ElectraNet Revenue Proposal 2023-28

# **REVIEW OF PROPOSED CYBER SECURITY AND CLOUD MIGRATION OPEX STEP CHANGE: PUBLIC VERSION**

Report prepared for:  
**AUSTRALIAN ENERGY  
REGULATOR**  
August 2022

Figure 2.1: ElectraNet ICT total expenditure – historical and forecast (\$m 2023)

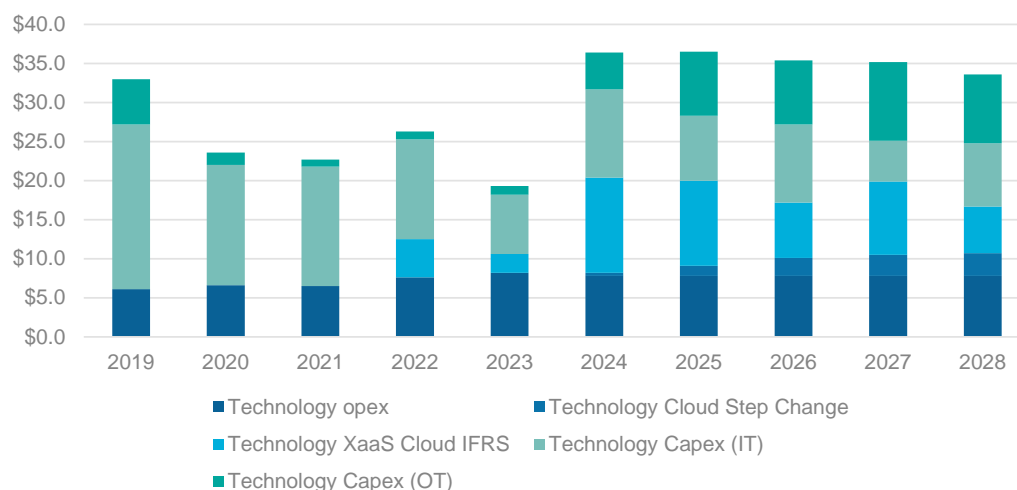
18. The information ElectraNet provided in response to an Information Request shown in Figure 2.1, Table 2.1, and Table 2.2, shows that ElectraNet is proposing 'Technology XaaS cloud IFRS' expenditure<sup>2</sup> of \$45.5m over the next RCP. This is in addition to the \$9.6m for the 'Technology Cloud step change' (which we infer to be the Cloud migration step change, noting the quantum is different to the \$9.0m in the RP) and the Cyber security step change.
19. However, in ElectraNet's opex forecast model, the \$45.5m of additional opex is identified as a step change.<sup>3</sup> In response to an Information Request, ElectraNet advised that:<sup>4</sup>

23. This leaves us with the hypothesis that the proposed cyber security step change is not included in the ICT/OT expenditure forecast that ElectraNet provided as its IR014 response. On this basis, the increase in ICT/OT totex would appear to be a further \$5.2m per year greater than is shown in Figure 2.1.
